Flight Procedures Cover Page	Task Action: FLIGHT CHECK	Task Type: IAP	Estimated Chart Date: 11/03/2022	APWS Task ID: 6755D6D1CC6846E5BFD78E2773FA1D39	APWS Project ID: 90CD22B362A940A9B70F3C942E5122CD
Procedure: RNAV (GPS) RWY 7 ORIG		Enroute: NO	Specialist: Sarmiento, April		Agreement Number:
Airport ID: KHHR			Airport City: HAWTHORNE		State: CA
Facility ID:	Facility Type:	Flight Inspection Remark Type: Hold FC Slot

FIPC BASIC FORM						
PROCEDURE: RNAV (GPS) RWY 7 ORIG			AIRPORT NAME: JACK NORTHROP FLD/HAWTHORNE		AIRPORT ID: KHHR	SPECIAL CONTROL NO: SG-07-315-22
FAC ID: KHHR07		CITY: HAWTHORNE			ST: CA	ORIG CHART DATE: 11/03/2022
DFL TYPE: PROC/S	THIRD PARTY: <input type="checkbox"/> YES	EST. TIME ON SITE: 0.4	REIMB. NUMBER: AC0598	PTS TASK ID: 6755D6D1CC6846E5BFD78E2773FA1D39		
PREFLIGHT NOTES						
REVIEWER:					DATE:	
COMMENTS:					CHECK ONE: <input type="checkbox"/> FLT CK REQ <input type="checkbox"/> NFCR <input type="checkbox"/> REJECT	
					YES	NO
					CPV COMPLETE? <input checked="" type="checkbox"/> X <input type="checkbox"/>	
PROCEDURE RESULTS						
INSPECTION DATE: 08/23/2022	CREW #: VN502	N #: N79	INSTRUMENT PROCEDURE STATUS: <input type="checkbox"/> SAT <input checke

AUTOMATED AL-5120 RNAV (GPS) RWY 7

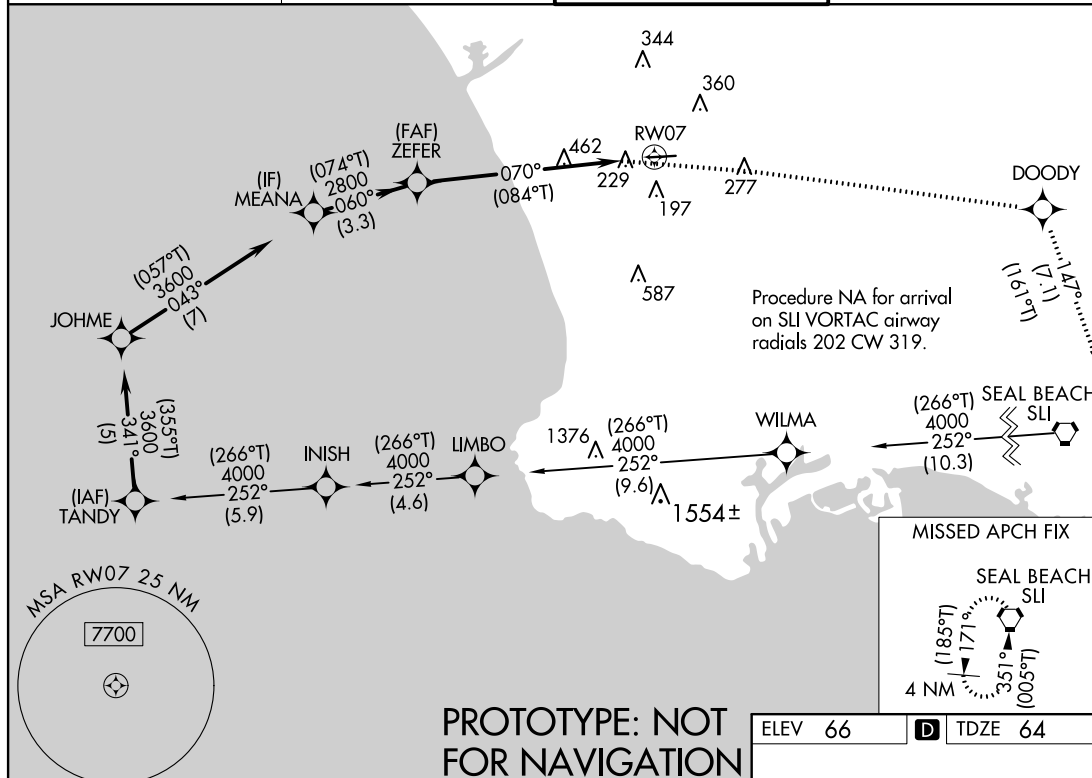
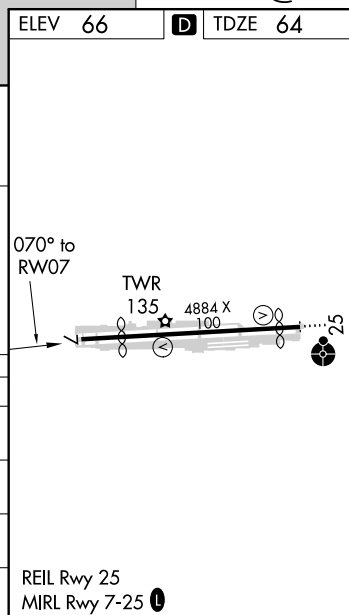
1. TERMINAL ROUTES: CHANGED SEGMENT FROM "ZEFER TO RW07" TO "ZEFER TO (CFLBQ)" AND CHANGED COURSE FROM 069.76 TO 069.68, AND CHANGED DISTANCE FROM 7.30 TO 7.31

2. TERMINAL ROUTES: CHANGED SEGMENT FROM "RW07 TO 341 MSL" TO "(CFLBQ) TO 342 MSL" AND CHANGED COURSE FROM 069.76 TO 069.68
3. TERMINAL ROUTES: CHANGED SEGMENT FROM "341 MSL TO DOODY" TO "342 MSL TO DOODY"

4. MISSED APPROACH MAP: CHANGED FROM "LNAV: RW07" TO "LNAV: (CFLBQ)"
5. PROFILE LINE 3: CHANGED FAC FROM 069.76 TO 069.68, CHANGED DIST FAF TO MAP FROM 7.30 TO 7.31 AND CHANGED DIST FAF TO THLD FROM 7.30 TO 7.31

6. PROFILE LINE 5: CHANGED DIST TO THLD FROM "277 HAT: 0.59" TO "278 HAT: 0.59"
7. PROFILE LINE 7: CHANGED FROM "RW07 7700" TO "CFLBQ 7700"
8. ADDITIONAL FLIGHT DATA: ADDED "CHART IN PLANVIEW: FINAL APPROACH COURSE OFFSET 2.99 DEGREES"

9. ADDITIONAL FLIGHT DATA: ADDED "FICTITIOUS THRESHOLD POINT (CFLBQ)"
10. ADDITIONAL FLIGHT DATA: CHANGED NOTE FROM "CHART: KCPM IN PLAN AND PROFILE VIEWS" TO "CHART: KCPM IN PLANVIEW"

11. MINIMUMS: CHANGED LPV ALL CATS FROM "DA/341/VIS 1/HAT/277" TO "DA/342/VIS 1/HAT/278"
12. FAS DATA: LTP/FTP LATITUDE/LONGITUDE CHANGED FROM "335521.3925N/11820245205" TO "335521.9585N/11820245765W"
